Mill Creek Estates Homeowner Association Inc. (Phase I)
Springfield Illinois
November 12, 2017 at 3:00 p.m.
Held at Kerasotes YMCA

Proposed Detention Pond Improvements

Comments 041217

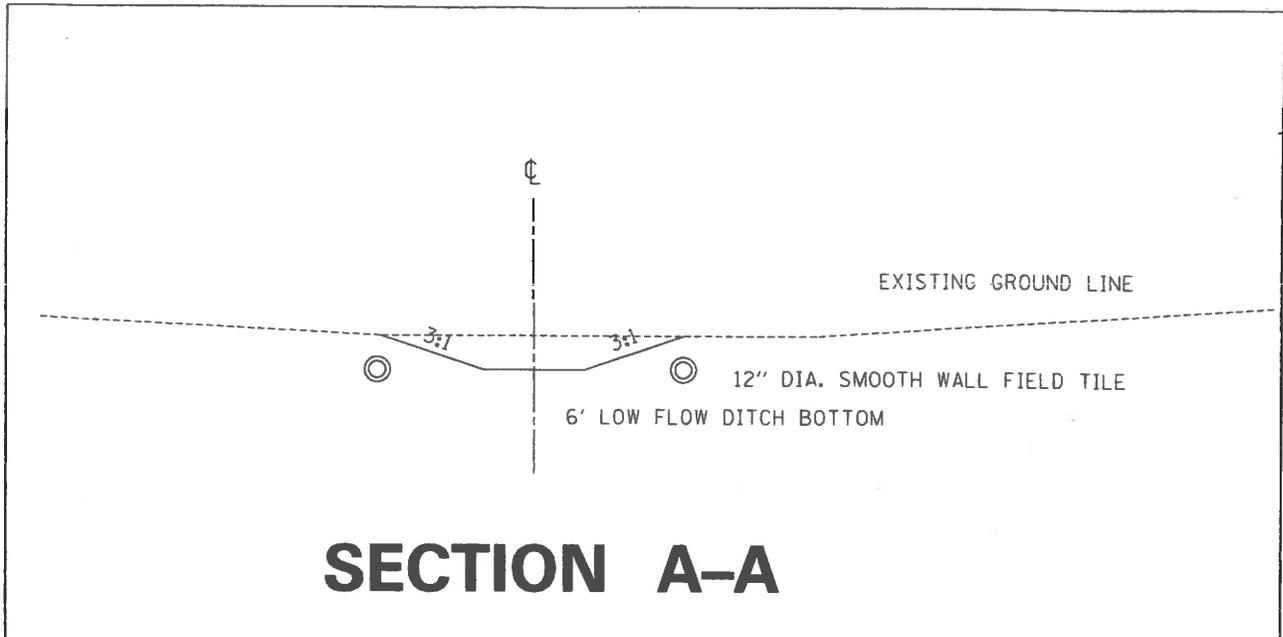
1. Why remove and relay existing rip rap? Does ditch need deepening, or does this material go into new low flow channel? This pertains to both the existing rip rap immediately adjacent to the outlet structure and the existing rip rap that runs along Meadowbrook Road near the toe of the existing pond slope. For obvious reasons, I would like to reuse the rip rap adjacent to the outlet and recreate a basin for the ditch and smooth pipes to outlet into and drain to the existing 18" concrete pipe. The rip rap along Meadowbrook Road does not seem to be fully functional and in some locations, seems excessive. Ideally, this area should be reconfigured to be closer to the toe of slope and better coordinated with the existing drainage inlet pipes. Excess rock could be used for the basins.

2. Regarding removal of existing field tile, presume this means in main channel area? What about laterals that were added couple years back? I wouldn't actively seek to hunt out and remove all field tile, but I am guessing that there are areas that we are going to cut into or cross that will render it useless, if it even works. If the main channel is removed, the existing laterals will likely be cut as well.

3. We have been told that field tile with sock will become blocked because of high silty soil? That is what was installed couple years back? Will it have gravel placed around it? There are different schools of thought on sock versus no sock. I prefer the use of sock. If the water can percolate through the soil itself, it can get into the sock. Gravel can be placed around the pipe, but unless the trench is fabric lined, the gravel will quickly fill in with the adjacent fine soil. So it is either sock, or fabric lined gravel trench, with the first being considerably cheaper.

4. With respect to new 4" dia. field tile, how deep will it be?? What will protect it from mowing equipment and perhaps truck traffic? I would expect the 4" tile would range from 1' to 2' deep. This pipe can be laid nearly flat as is meant to collect water and push it through the system via pressure head. Mowing equipment should be the heaviest equipment, we can keep a band around the edge of the pond clear of pipe for truck traffic if necessary.

5. Are we re-grading the entire basin area to insure positive slope to the low flow channel?? Then re-seed it appears? Certain areas are low now near residences and preclude mowing, will these be addressed in the regrading? The desire would be to regrade the bottom of the pond basin to provide positive drainage to the low flow channel. The only catch is that any grading greater than one acre of area triggers another level of permitting, engineering submittals and fees. If we could keep it below an acre, that would be preferred, but if the work needs to be done, now is the time to do it.

6. The solid field tiles will be primary method of water removal when very low flows? Larger rains will use both tiles and then low flow channel? In heavy rains the detention basin will then hold until drainage can exit? Yes, this is essentially how the system will work. The intent is to get the lower intensity rainfalls and flow through the site without inundating the entire bottom of the pond. If these lower flows can be contained, it will help to keep the remainder of the pond dry and mowable. For larger events, the pond will and must fill up for the purpose of flood control. (Likely to happen this weekend with all the rain anticipated). But with this system in place, the basin will dry out faster and not be

7. **How exactly will solid field tiles be installed/treated at downstream side? Open ends? Is there to be a basin at the downstream side? Will water just set in pipe? Survey shots were taken and there is approximately 2 feet of fall from the 36" pipe to the outlet structure, 18" pipe. The ditch would be cut to grade to connect the inlet and outlet directly on one slope. The solid pipes would flank the ditch and be placed matching the invert at the downstream end, but the pipe would be flattened to about 1/2 of the slope of the ditch, thus creating approximately a 1 foot sump at the upstream end. A rock (riprap) basin would be constructed at the upstream end funneling the flow from the 36" concrete pipe into the 2 smooth tile pipes. At first the flow would fill these pipes, then the flow would be directed to the ditch once these pipes fill up. A rock basin will also be constructed at the downstream end (using the existing rock currently in place) to funnel the water from the smooth tile pipes and the ditch into the 18" outlet pipe.**

8. **What will protect the entrances/exits to the solid field tiles? Special inlets?**

9. **Will there be a downstream basin that the solid tiles exit into? Will they be cut into concrete drainage inlet at Meadowbrook?**

10. **Does the drainage structure wall at Meadowbrook need to be cut/lowered to give positive drainage of the field tiles? No, the 36" RCP pipe upstream and the box/grate control structure would not be impacted. These structures control the flow entering and leaving the site and should not be altered.**

11. **Should any sort of clean outs or access points be installed along field tiles and solid pipe? The smaller diameter tile would not have a cleanout. Due to the small diameter of the pipe, the material type and the branching connections, the effort to clean out this pipe would exceed the cost to simply replace it. In terms of the solid pipe, this system would be open at each end and could be jetted out if necessary, though the concentrated flow and velocity will likely keep this pipe pretty clean due to the smooth interior**

12. **Will it be possible to plant trees between the field tile runs in the future? Trees can be placed in the vicinity of the tile, but there is always a chance for root infiltration and blockage pending the type of trees selected. Some trees have a much more aggressive shallow root system, while other trees are deeper rooting or the roots are confined to the spread of the tree canopy. In all reality, the smooth tiles and the ditch, along with some regrading of the pond bottom will likely address 90% to 95% of your concerns. The 4" tile will just help dry things up if the pond fills up.**

13. **How will field tile locations be marked for future reference? As-builts with dimensions??**

This would simply be the rock basin surrounding the inlet to these pipes. The ends of the pipes would be open as to not restrict flow. The more flow you can get through these pipes, the better the system will perform.

Yes, there would be a similar basin at the downstream end that would tie to the existing 18" pipe from the outlet box structure. No modifications would be made to this structure.

This can be done by several methods. Sketches can be provided with ties (dimensions) to the underground pipe. Shallow buried metal stakes or magnetic nails can be placed along side the pipes and cross referenced on the plan sheets so that a metal detector can pick up the location, or some sort of a physical marker can be provided to identify the locations
